**Re: Lonza Biologics – Proposed Industrial Development
Traffic Peer Review Response 2
Supplemental PB Submission – Amended Site Plan Review Application**

PROPOSED INDUSTRIAL DEVELOPMENT

70 & 80 CORPORATE DRIVE PORTSMOUTH, NEW HAMPSHIRE

LAST REVISED: NOVEMBER 9, 2023

C-502

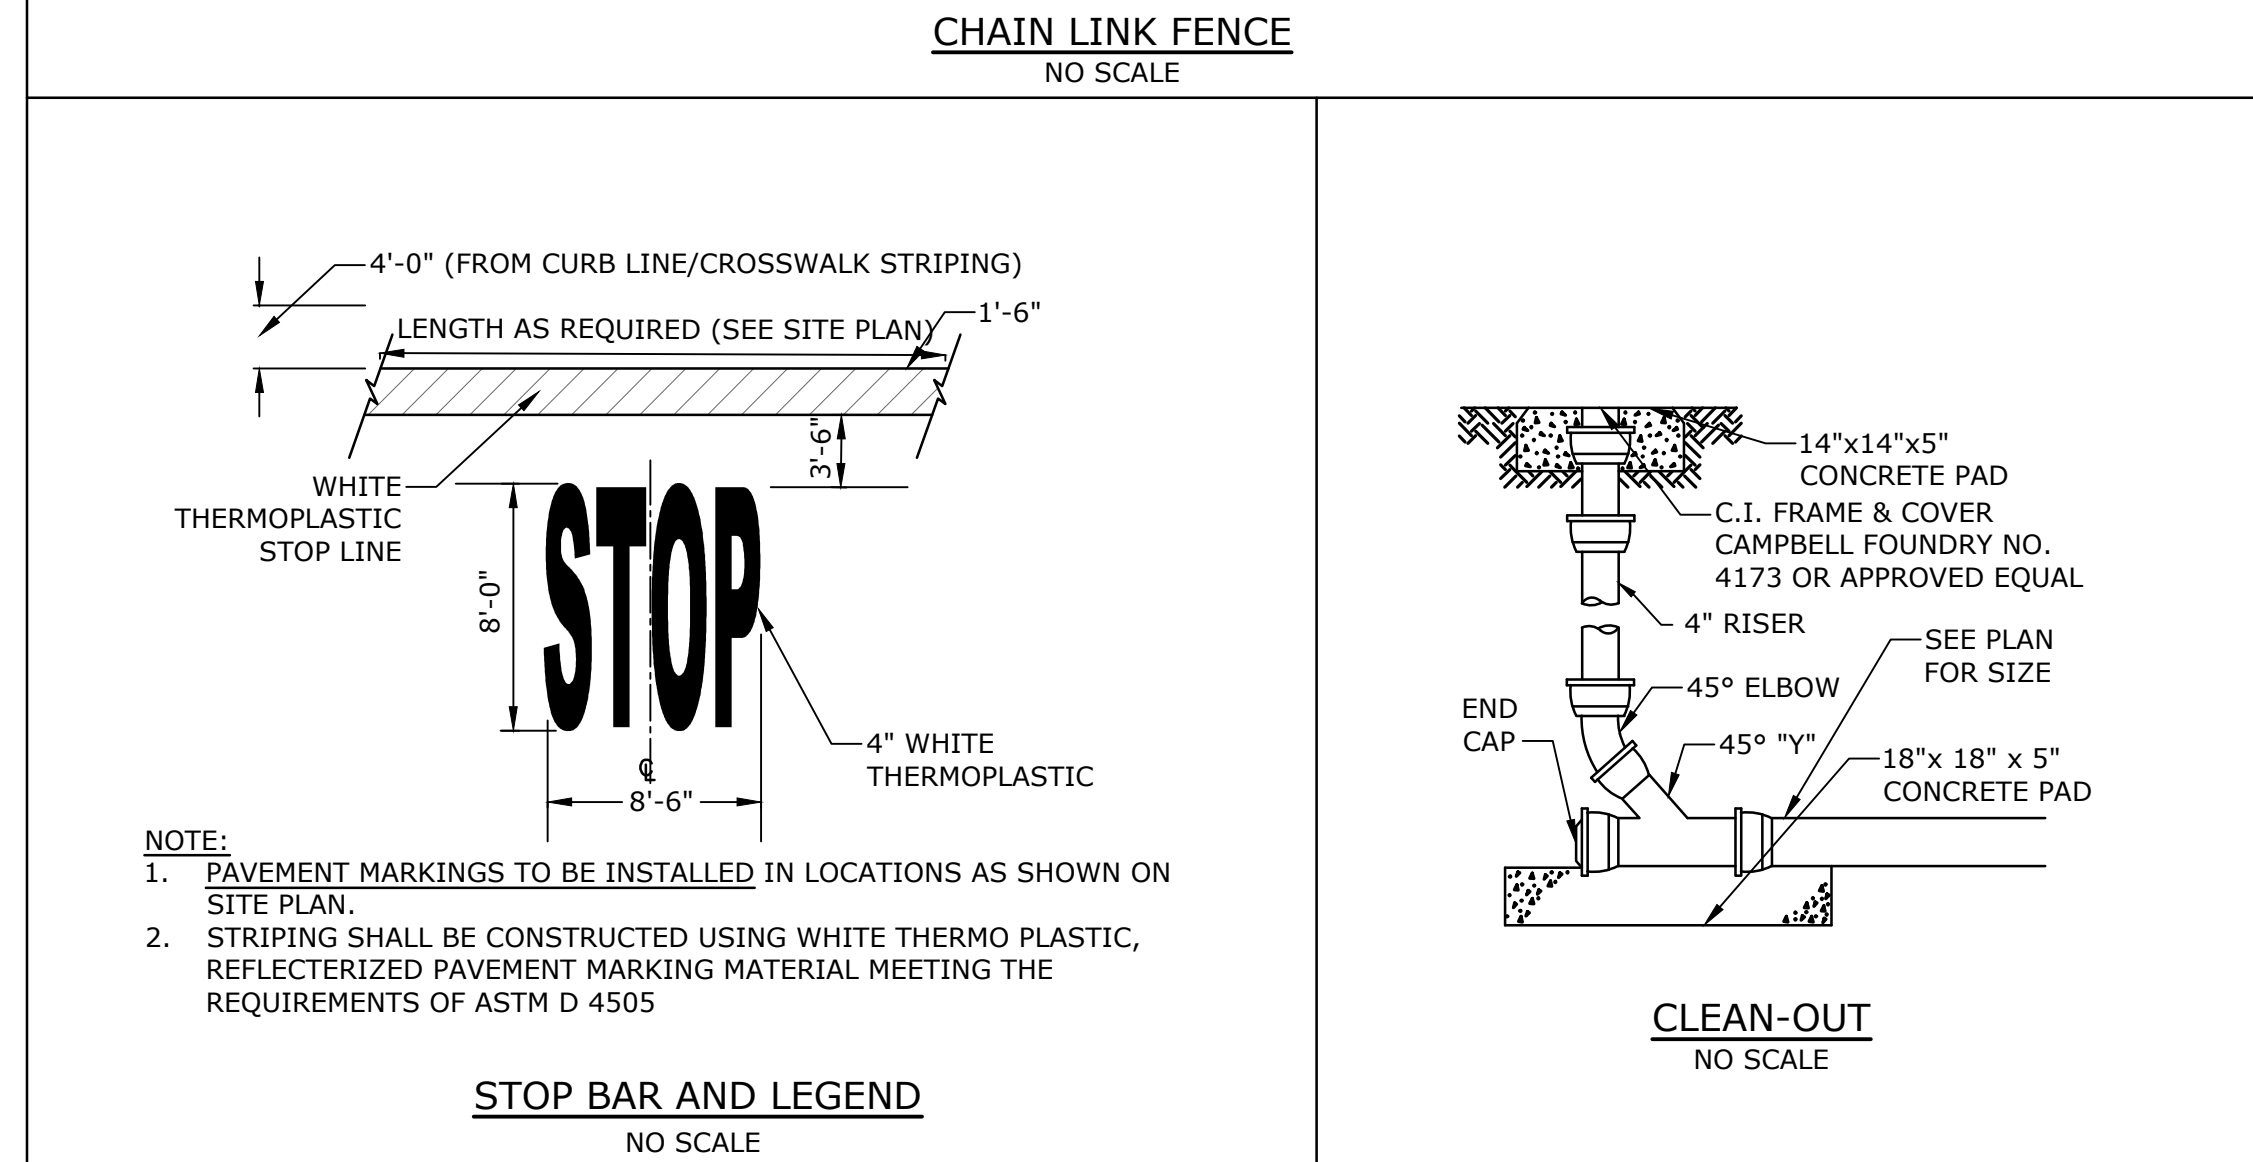
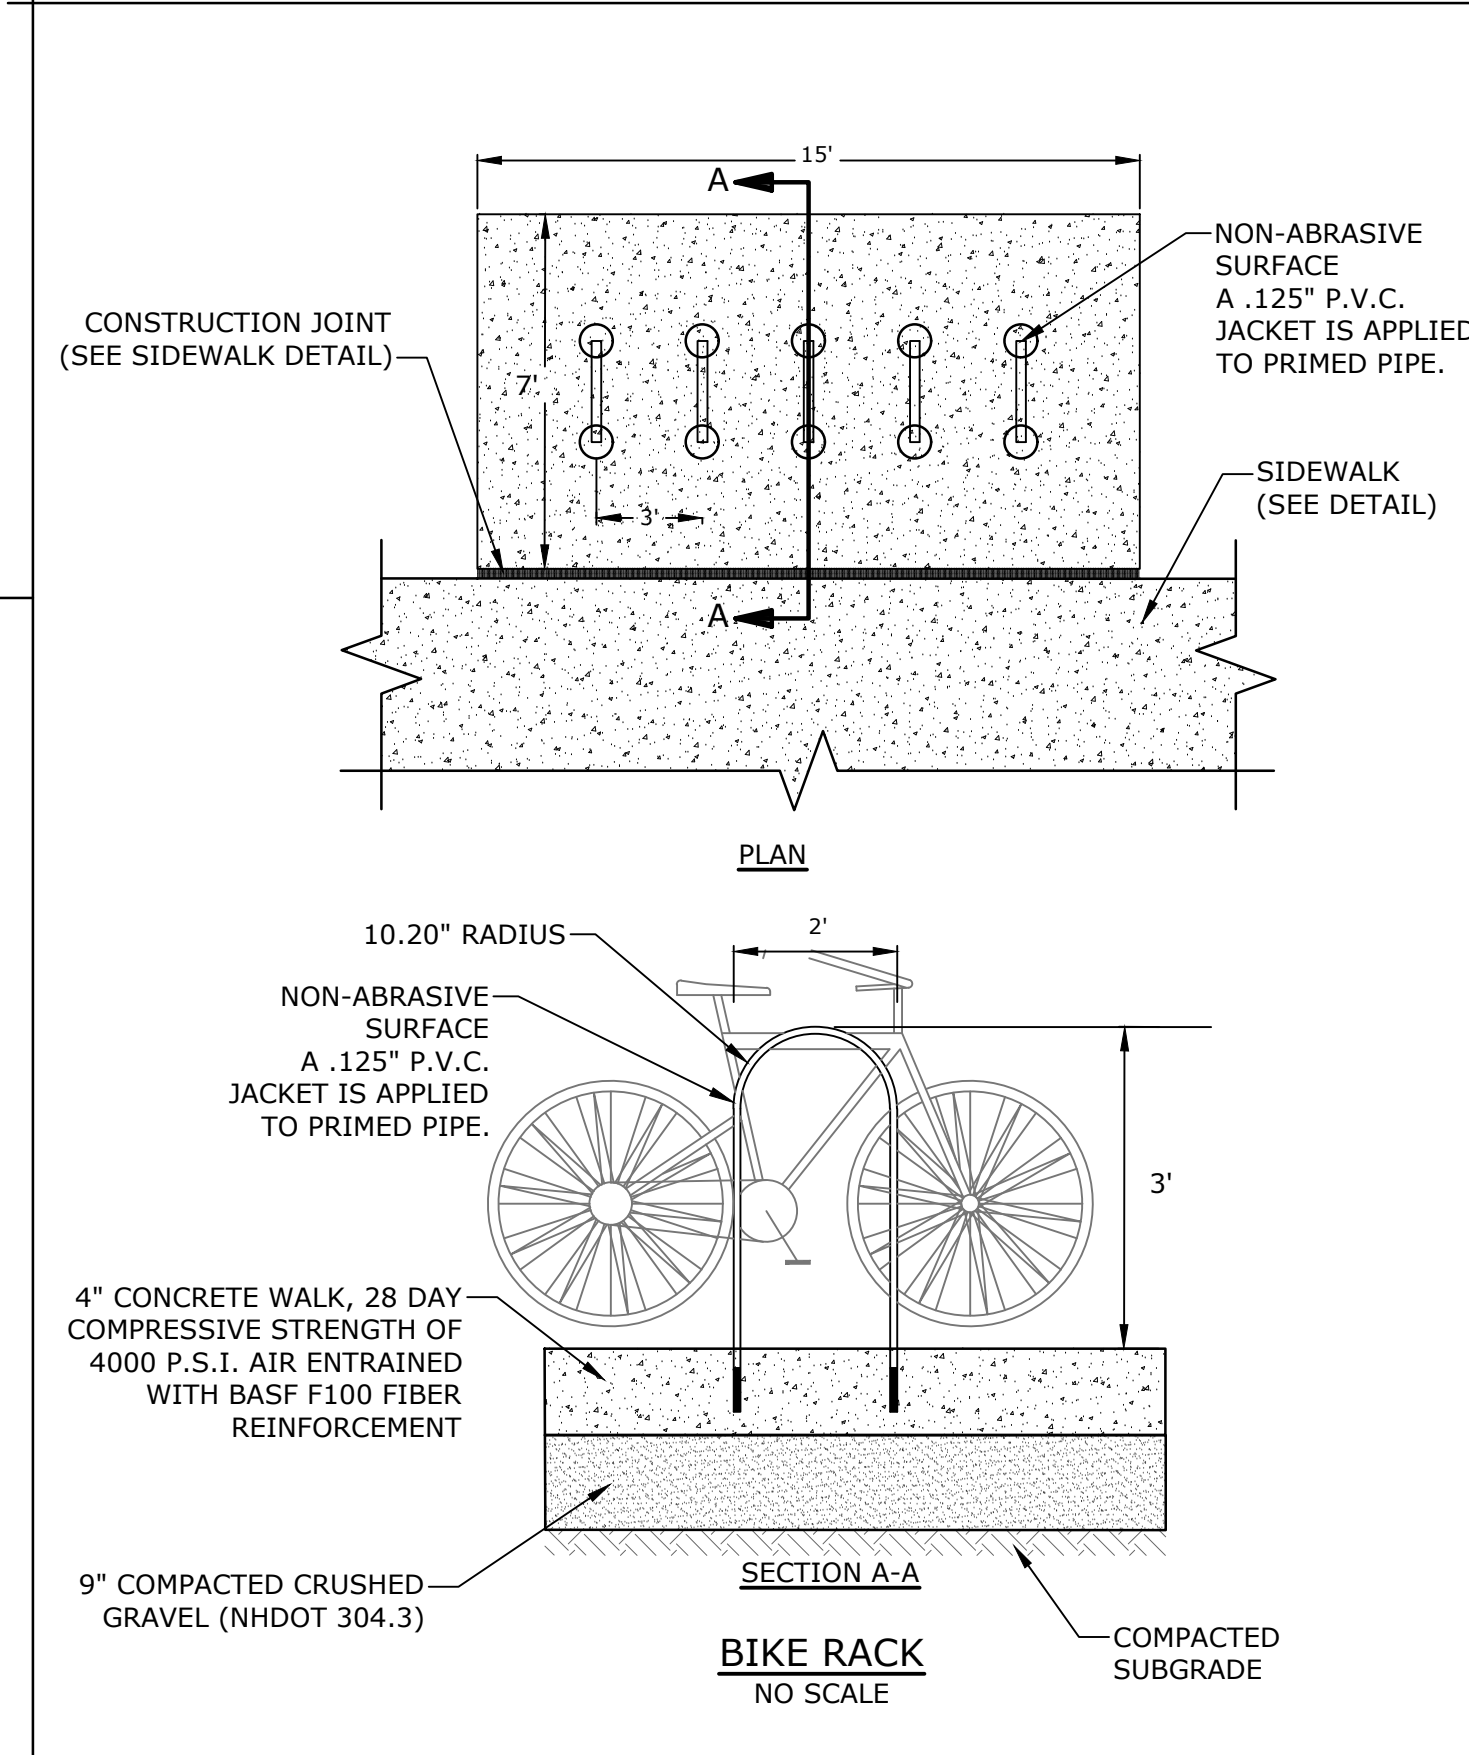
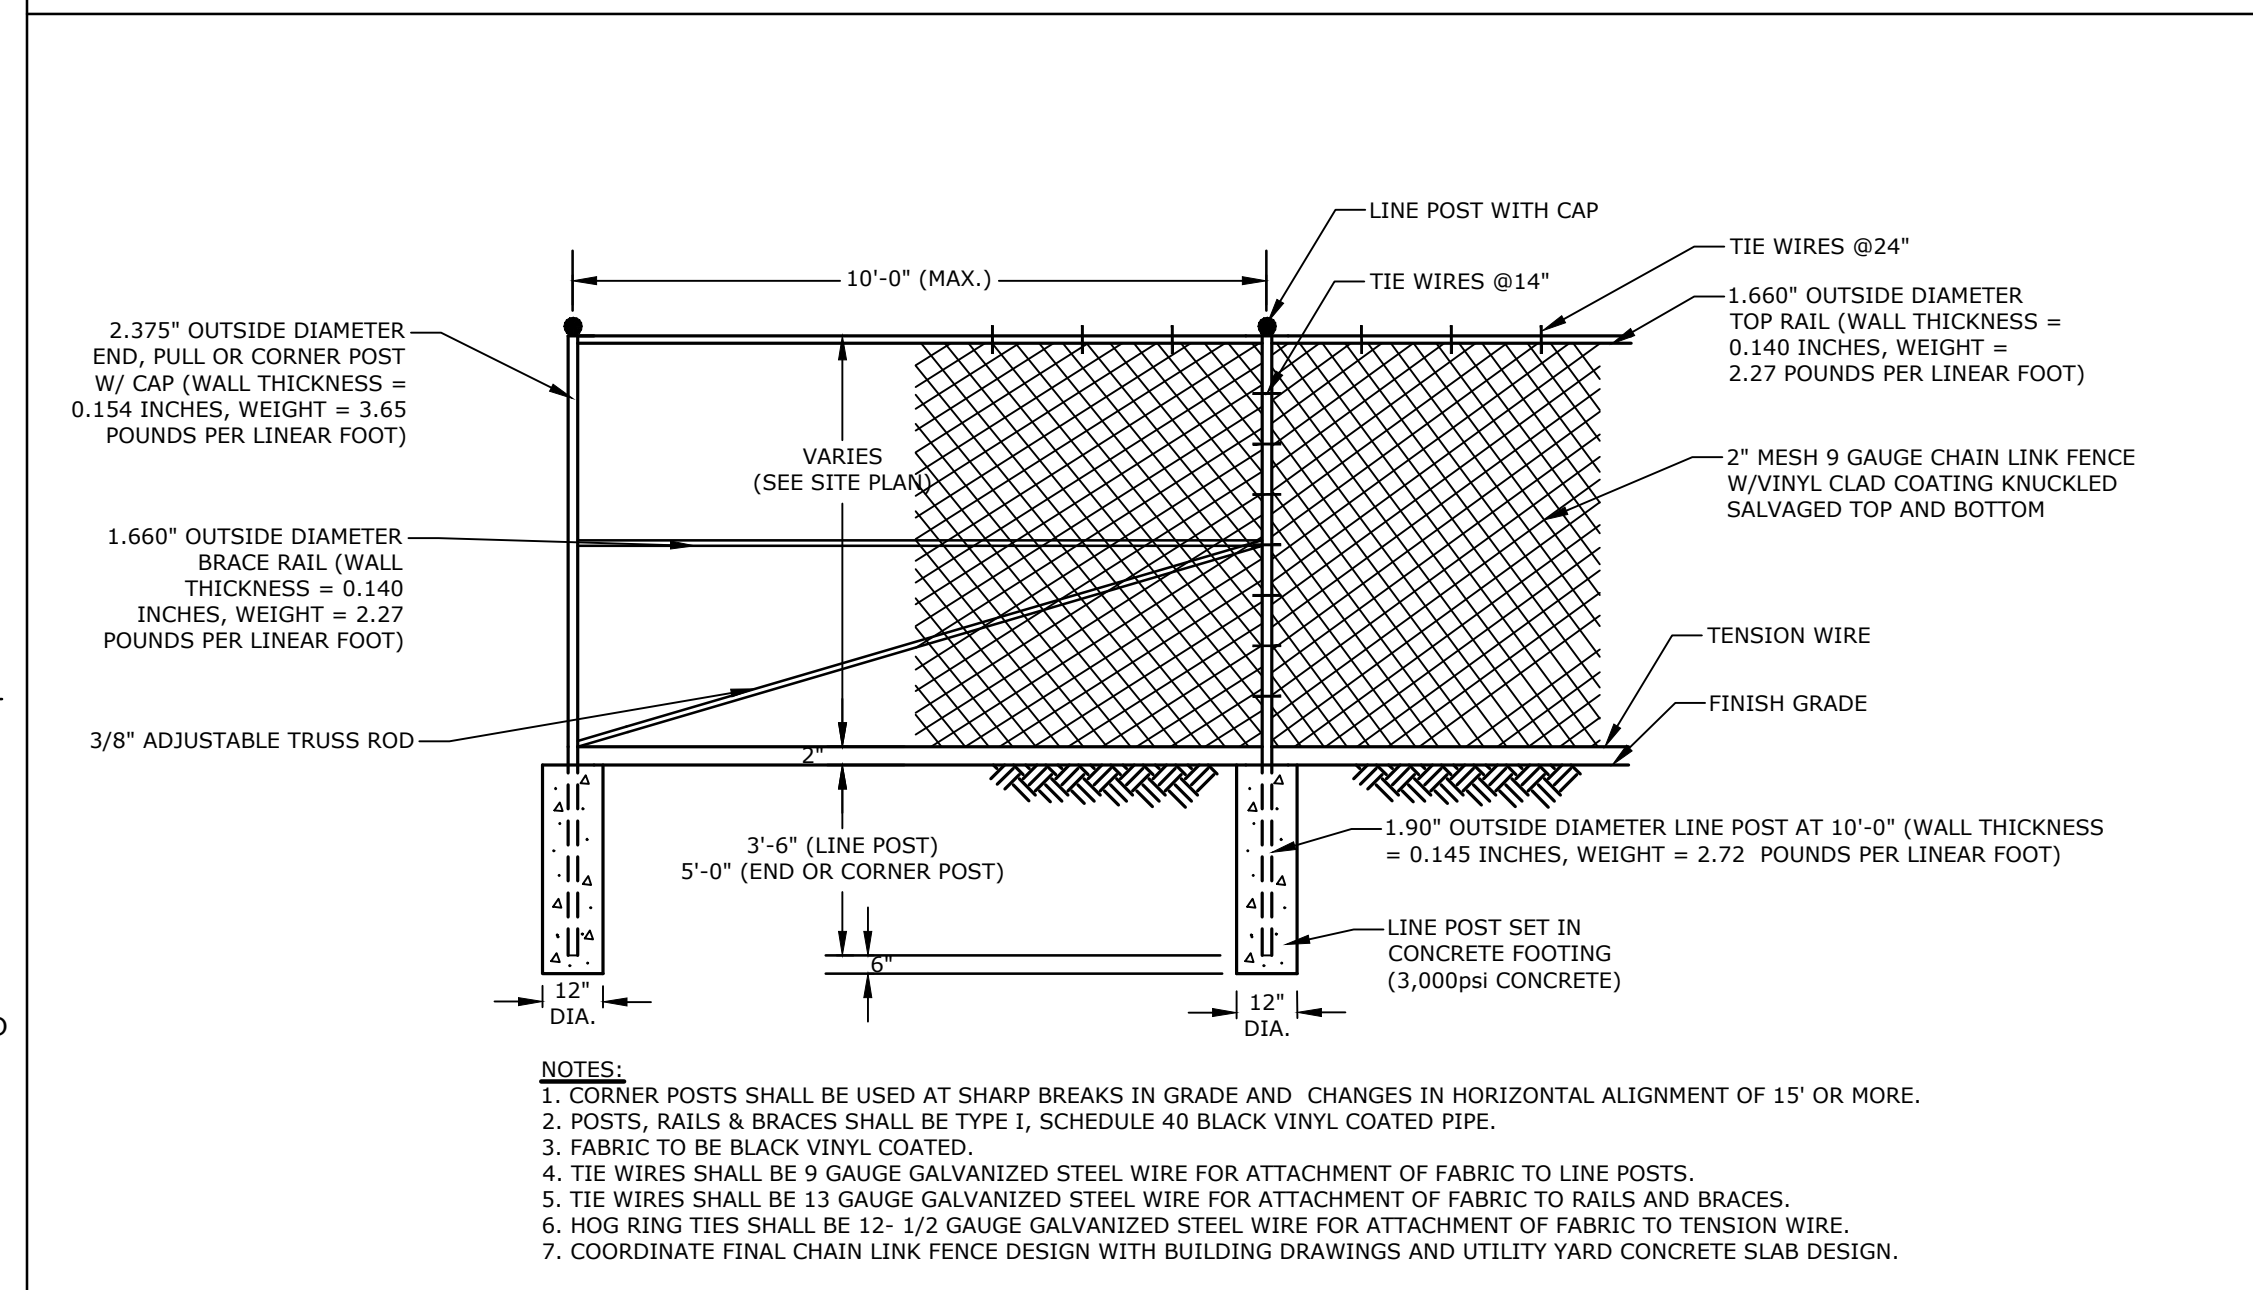
- A central sidewalk has been added through the 150 space parking area connecting to the currently proposed sidewalk. (Sheet C-165)
- A second trash compactor has been added to the site adjacent to the Utility Building. Truck turning was studied to confirm access. (Sheet C-166)
- Pedestrian warning signs have been added to the plans as recommended. (Sheets C-165, C-167 & C-502)
- Crosswalk Striping detail has been revised to note an 8' width. (Sheet C-502)
